RE: Curtis H. Stanton Energy Center Unit B IGCC
PSD Permit No. PSD-FL-373

Attachment 1
Updated Facility Design Drawings

Attachment 2
Revised Dispersion Modeling Results

Stanton Unit B
Revised Class II Modeling – June 2007

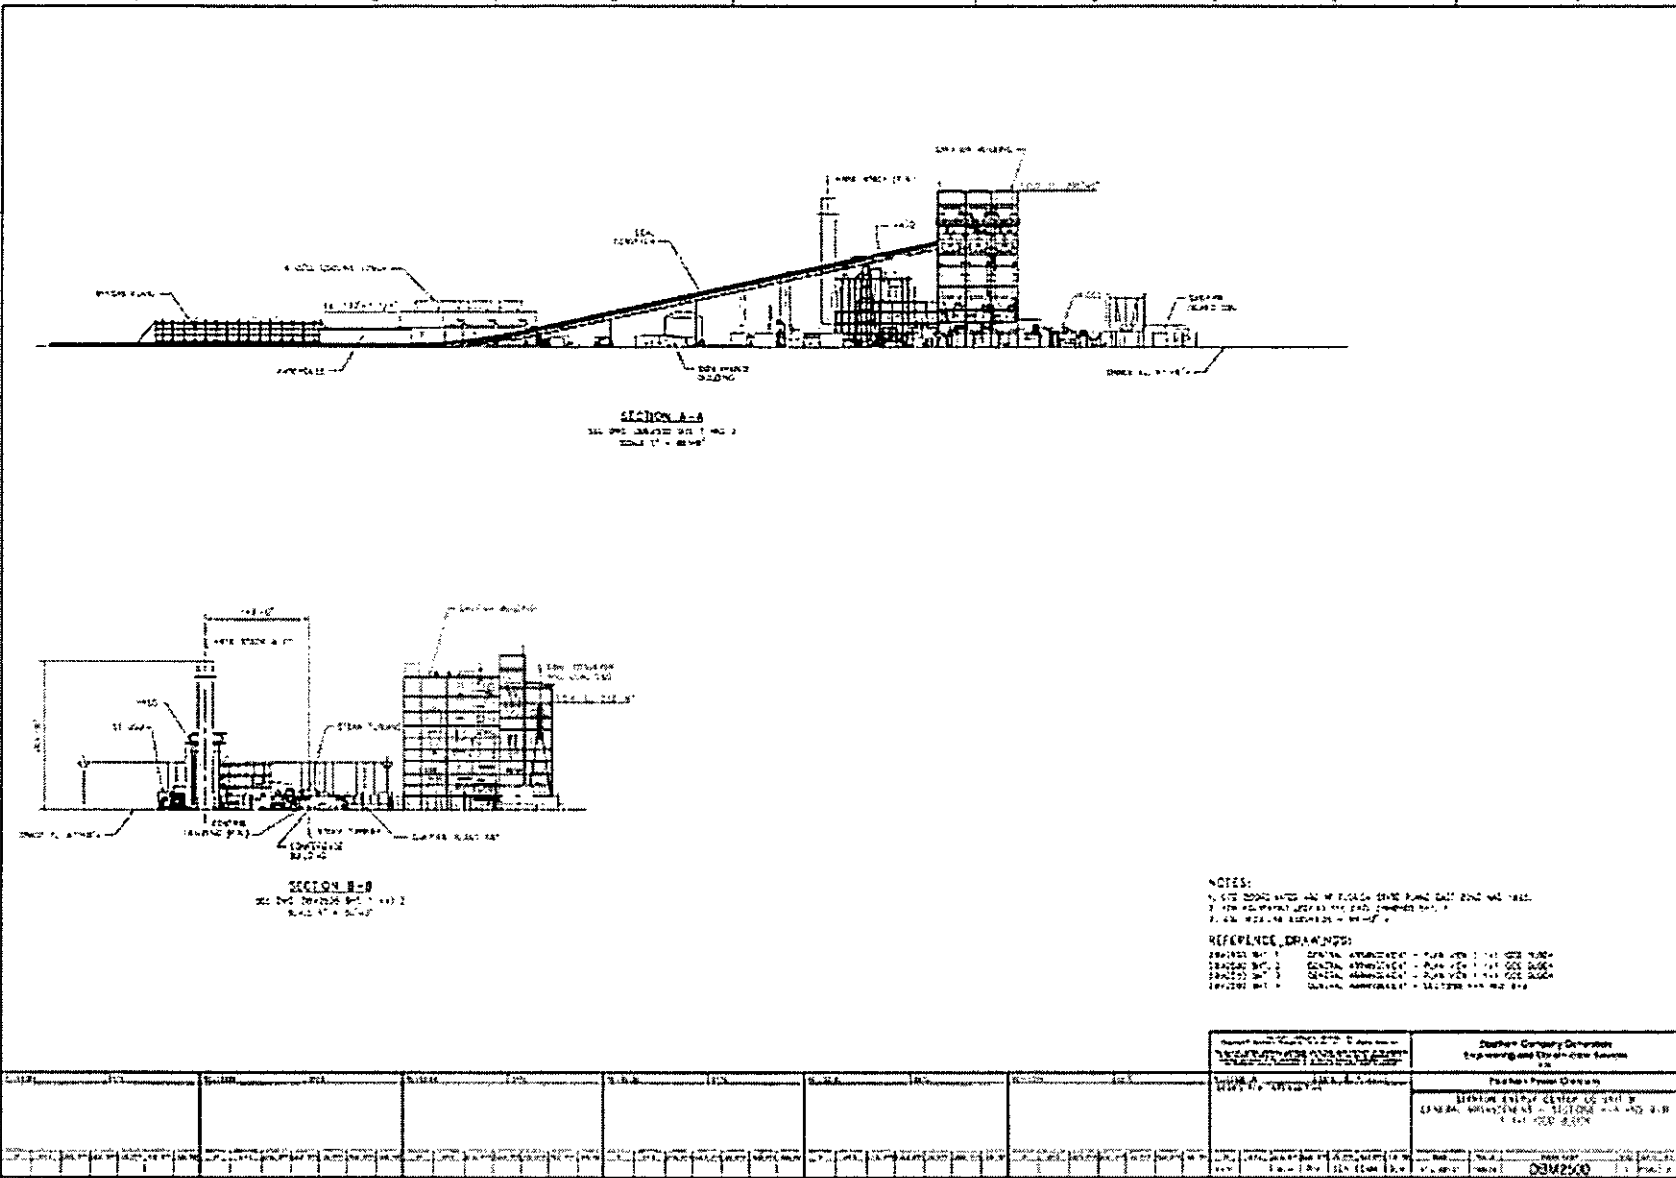
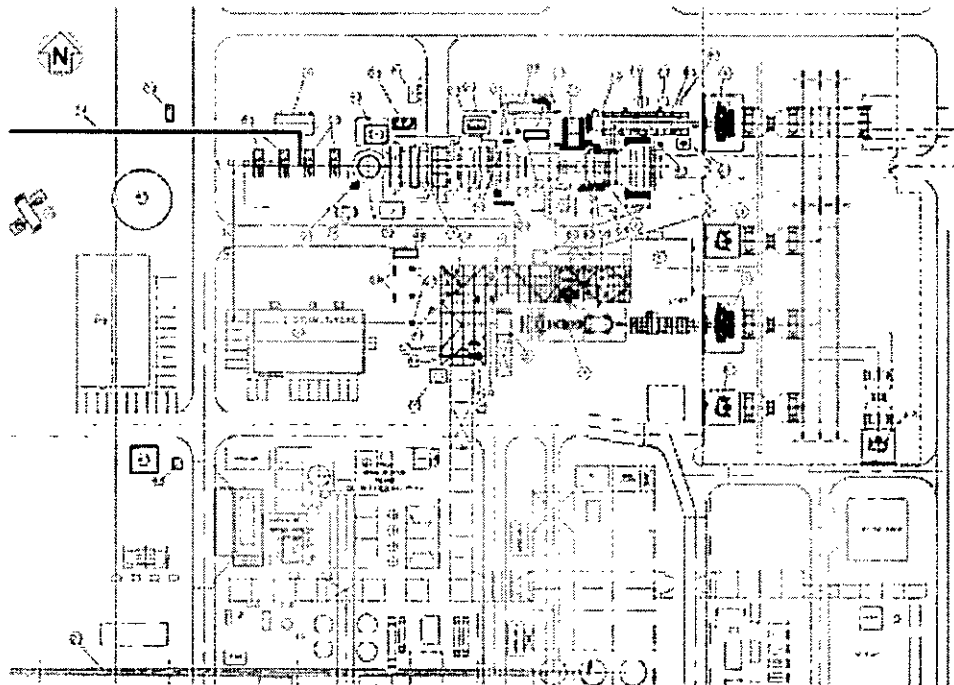
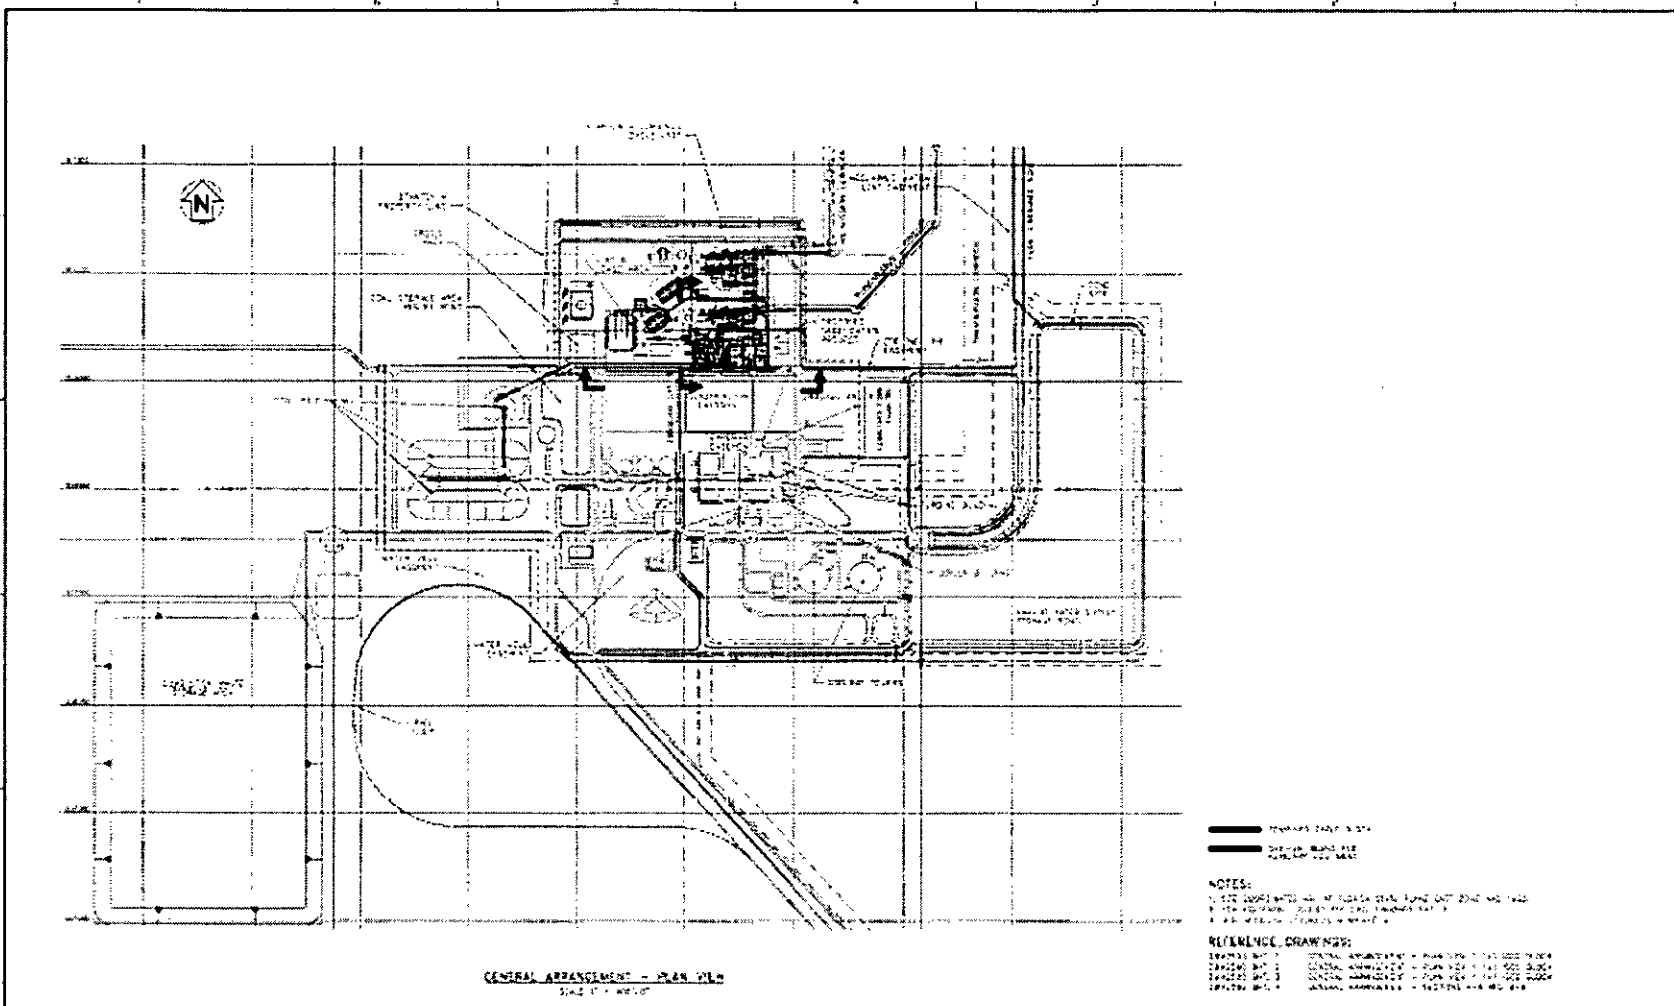
1. This project will require construction of a single gasifier vessel instead of two gasifier vessels. The coal input to and the syngas output from the single gasifier will be the same as presented in the original application as the total for the two gasifiers. A single gasifier is shown on the site drawings included in Attachment 1. With a single gasifier as opposed to two gasifiers, emissions during gasifier startup will remain within the estimates presented in the original application and will most likely be reduced.

2. This project will require certain site layout revisions in order to optimize the design and performance of the unit. Upon the conclusion of FEED, several structure heights and locations have been revised. These revisions are indicated in the design drawings located in Attachment 1. A revised air dispersion modeling study has been conducted considering the new layout and its results are included in Attachment 2. Impacts from all pollutants modeled remain below applicable modeling significance levels.

3. This project will require that certain components of the coal storage system be resized. The number of coal processing trains has been reduced from four to three resulting in the following revisions to the material handling system:

- The system will include three Crushed Coal Storage Silos (1-3) instead of the original four (referred to as Coal Storage Bins 1-4 in the original application). These silos will have a common baghouse that replaces the original four Crushed Coal Storage Silo 1-4 baghouses.

- A nitrogen purge stream will replace the original four coal mill silo baghouses.
 - The ash storage silo baghouse has been eliminated.
 - There will be a discharge from a makeup solids unloading system.

The overall result of these updates is that the number of emission points from the system is reduced, as are the total emissions from the system. These changes have been reflected in the drawings in Attachment 1 and in the revised dispersion modeling included in Attachment 2.
